YG-DCO-126

Yorkshire Green Energy Enablement (GREEN) Project

**Document 8.24 Applicant's Comments on Interested Parties' Deadline
4 Submissions**

**Final Issue A
July 2023**

Plan View 3
Low Loaders passing
Scale 1:200

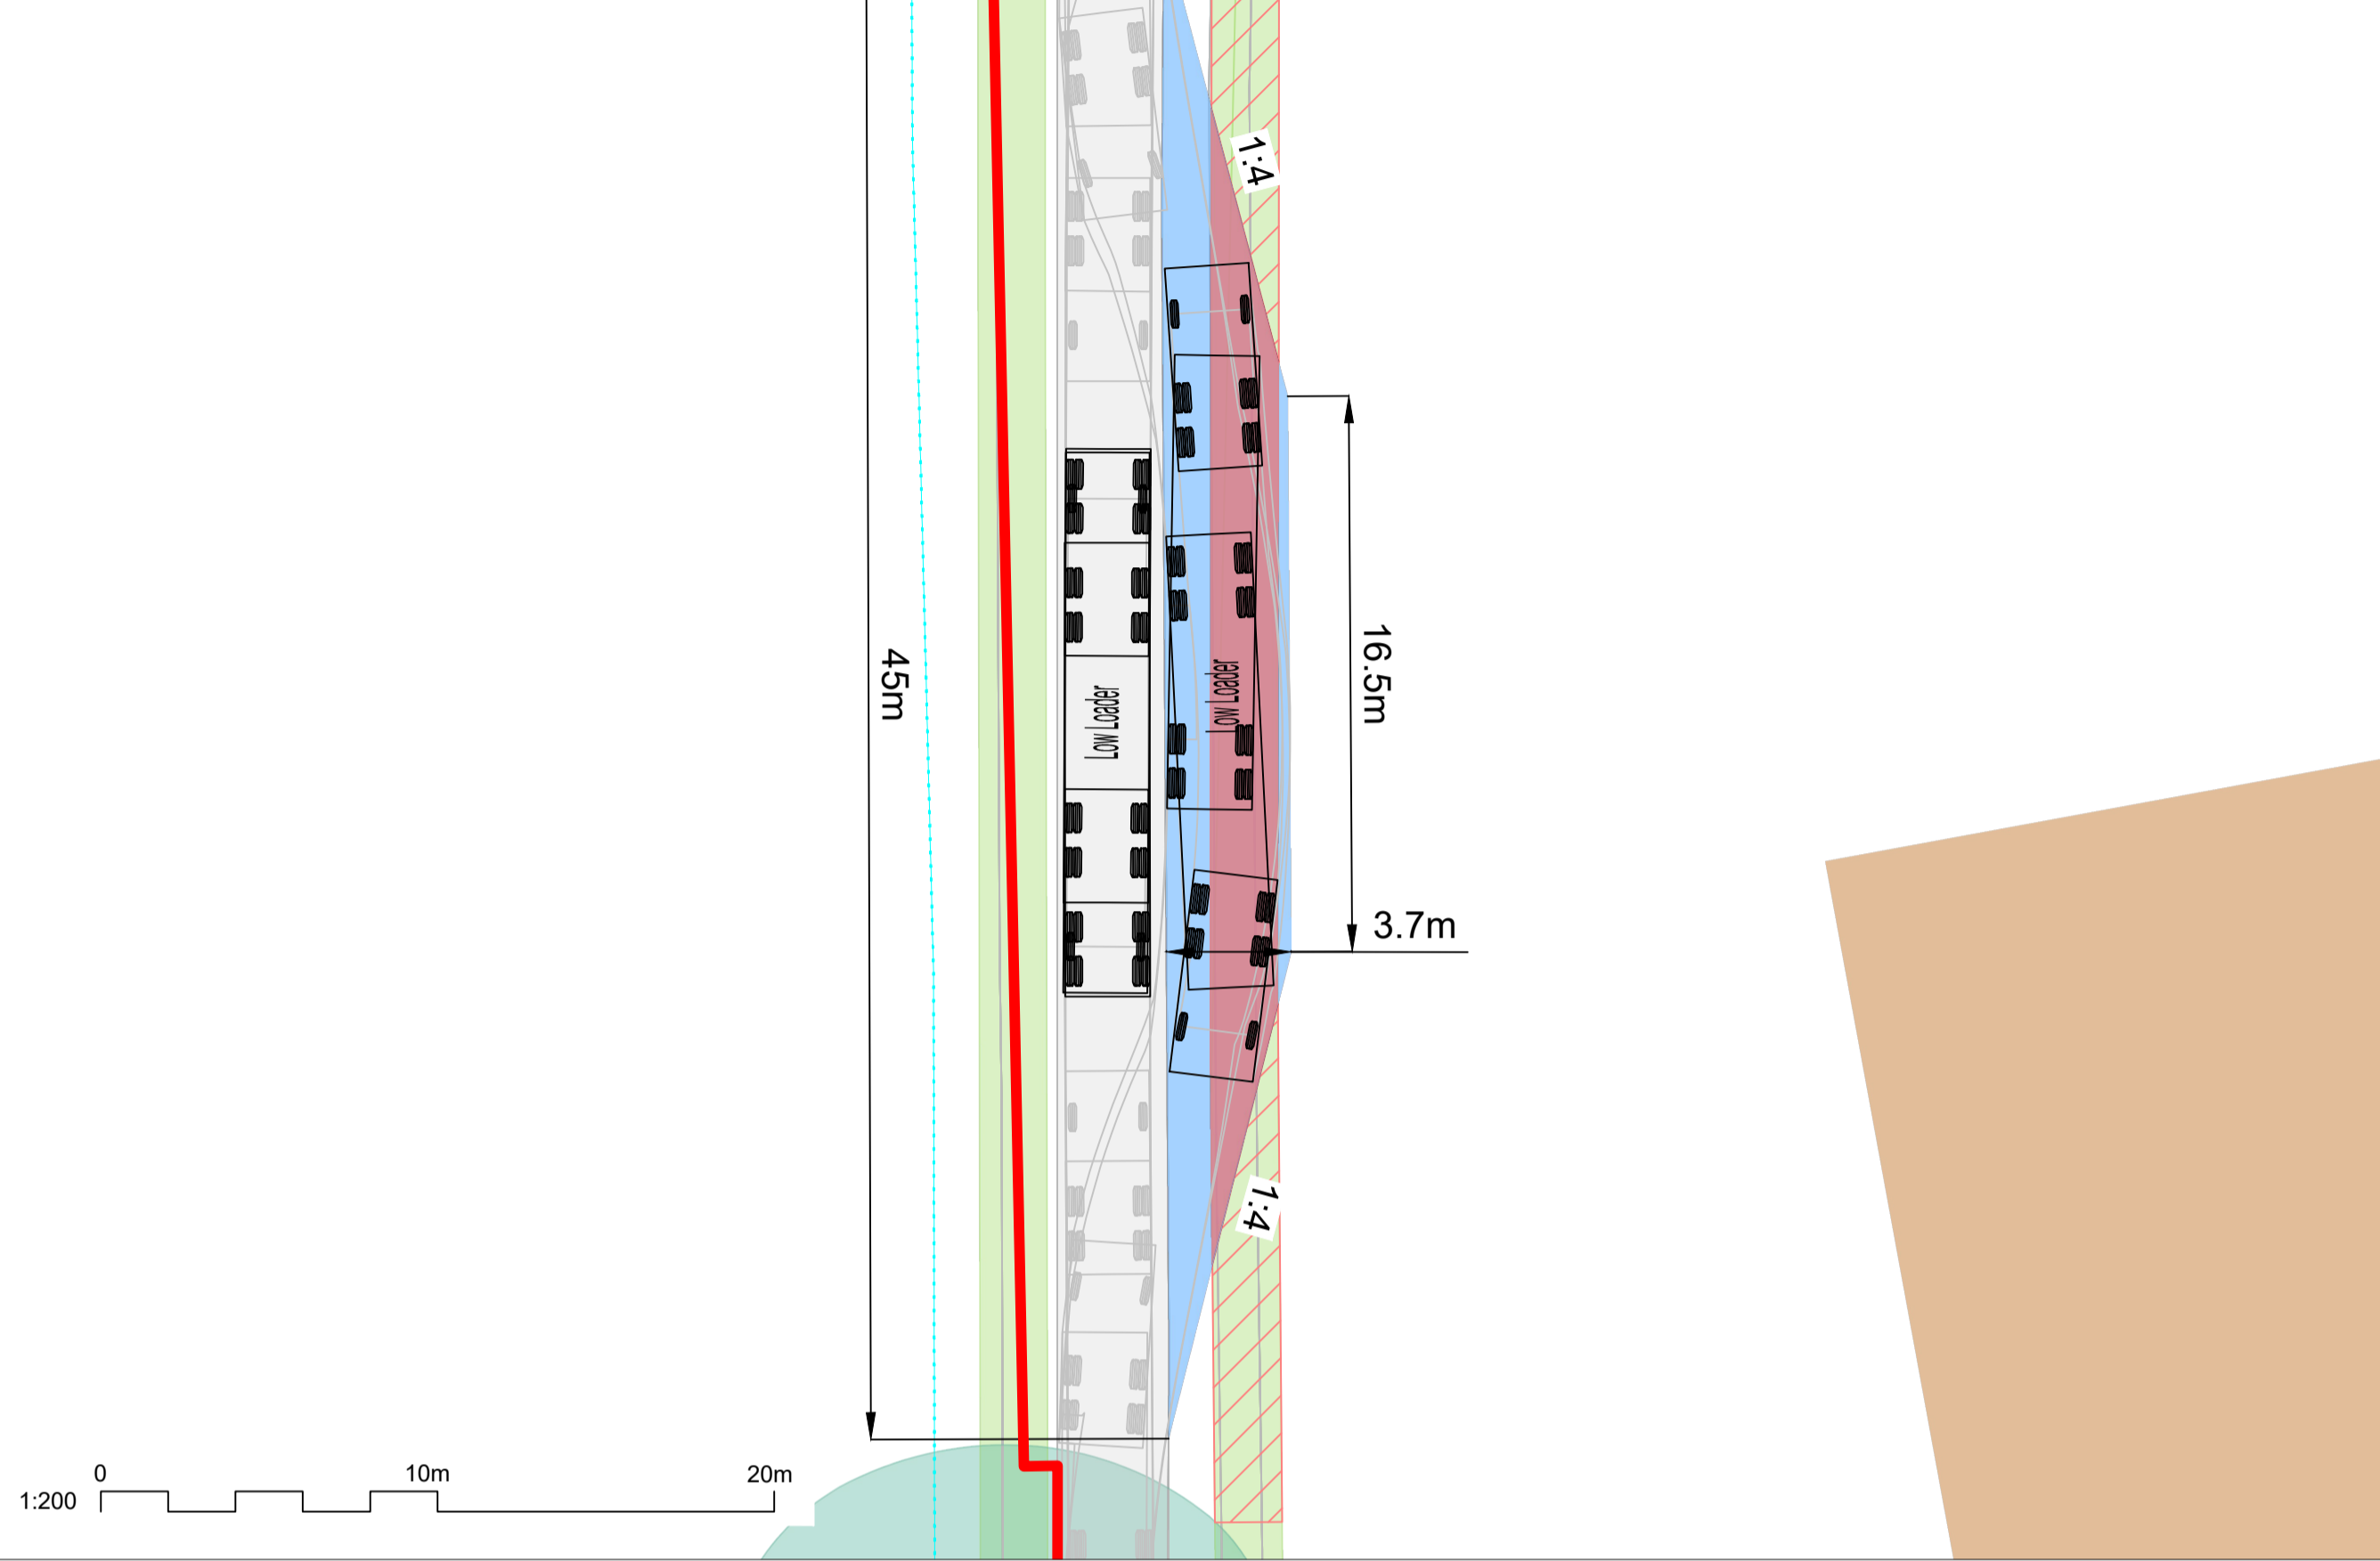
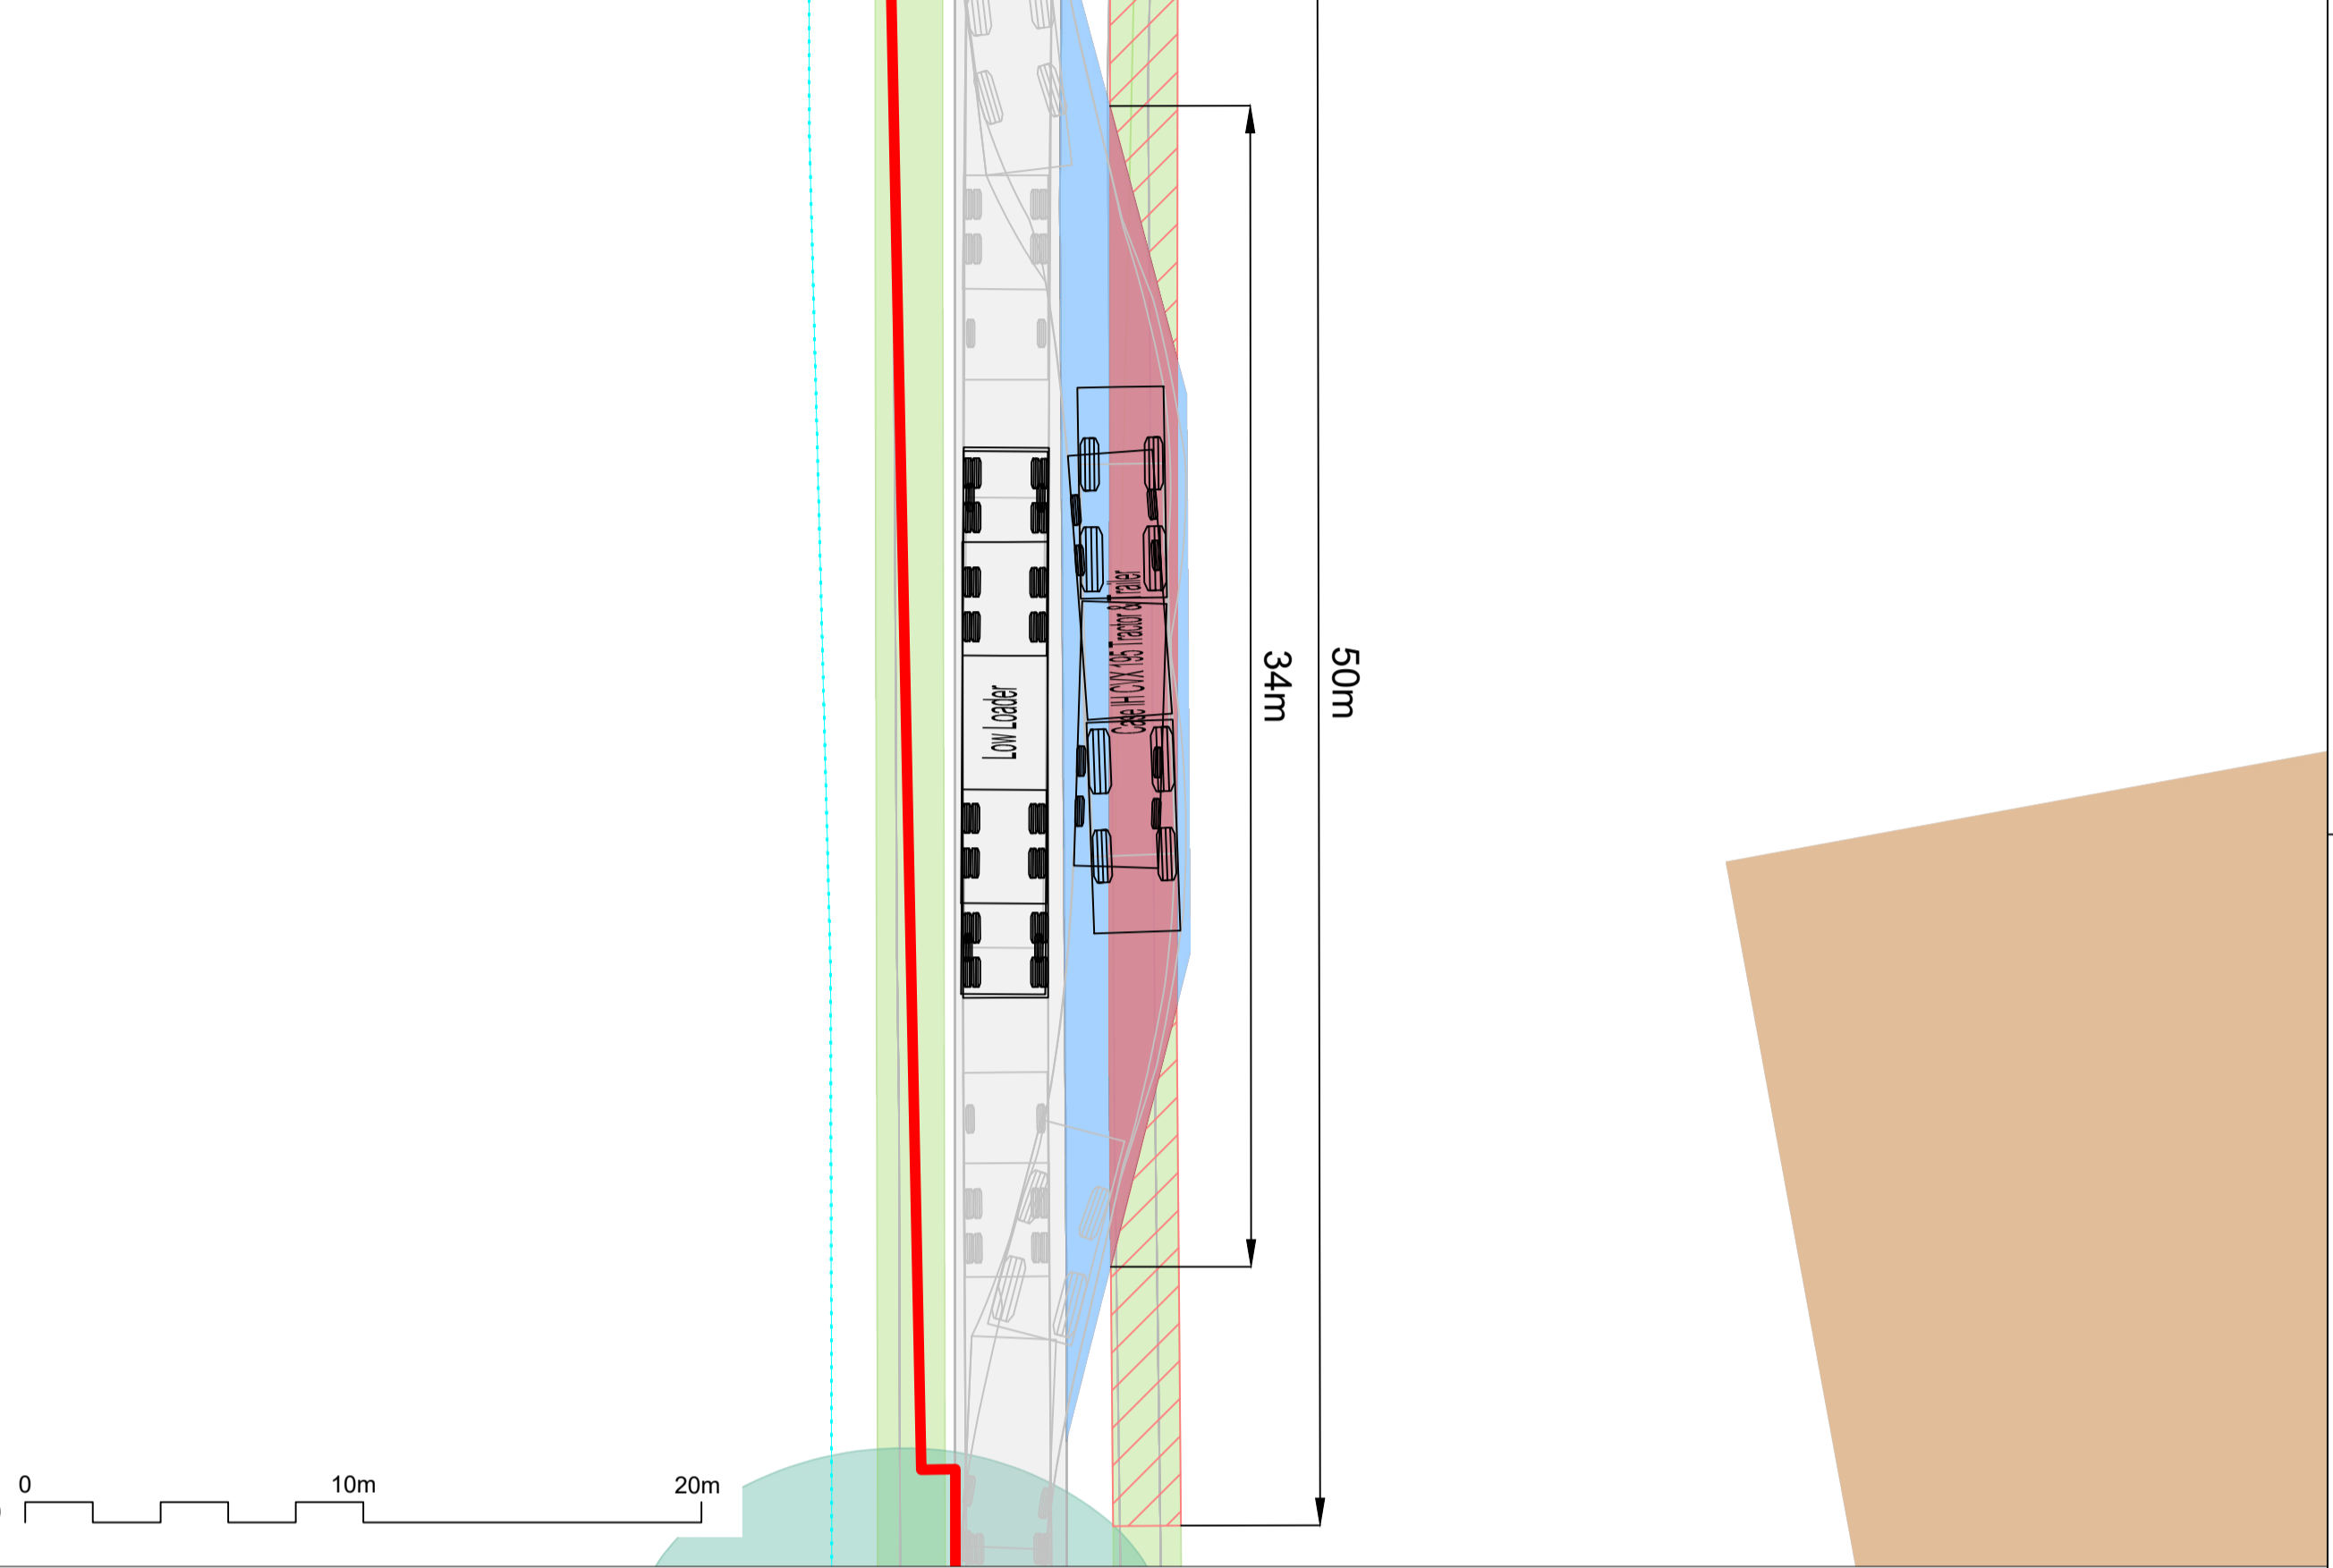
Reference	Topic	Applicant's Response
Action Point 22	Request for a meeting	National Grid met with Mr Stephenson and his clients on Friday 16 June 2023.
Action Point 30	Construction traffic and proposed alternative access.	a) National Grid note the deliveries required for the farming operations, and National Grid will manage the construction traffic to seek to minimise the impact on deliveries during the construction phase. This will be undertaken by the installation of passing places along the public

Reference	Topic	Applicant's Response
		<p>highway, which provide additional passing places to those provided in the bellmouths to be installed, as well as coordination with the Agricultural Liaison Officer (ALO), as set out in the Code of Construction Practice (Document 5.3.3B(C)) and the Traffic Coordination Officer (TCO) as set out in the Construction Traffic Management Plan (Document 5.3.3F (B)) submitted at Deadline 5. To aid understanding National Grid have submitted an illustration of what the road could look like with passing places shown (this is for illustration purposes only, and may vary a during detailed design), in Appendix A of this document.</p> <p>b) 25,525 vehicle movements (two way) shown in Appendix 12A Traffic Modelling Tables (Document 5.3.12A [APP-148]) are indicated for Access Points (AP) 95, 96, 97, 98 and 99. 12,858 of these movements will be to access point 95, which is on the junction of Corban Lane, with HGV movements coming from the east on Corban Lane turning right into this bellmouth, therefore will not be travelling further up Newlands Lane.</p> <ul style="list-style-type: none"> i. National Grid are not proposing to double the size of the road for the construction period as it is not necessary, suitable passing places will be included along the lane during the construction period. ii. National Grid are proposing to construct passing places to allow construction and farm traffic to pass on the lane. National Grid are awaiting the submission of a sketch of what suitable passing places would look like from Mr. Stephenson's the land agents and his clients point of view but have produced the above referenced illustration as this information has not yet been provided. iii. National Grid are not proposing a connecting road between the two construction compounds. The construction compounds are for use by separate contractors (overhead line contractor and CSEC contractor) and have separate access points, AP95 for the southern compound and AP98 for the northern compound.

Reference	Topic	Applicant's Response
		<p>Constructing a road between the two compounds would involve an additional stone access track and the removal of an additional amount of tress on the boundary between the two different land holdings which is not required. This change would also move the access onto another party's land. National Grid do not believe this isrequired, with traffic being managed along the lane, and passing places, and bellmouths being installed.</p>
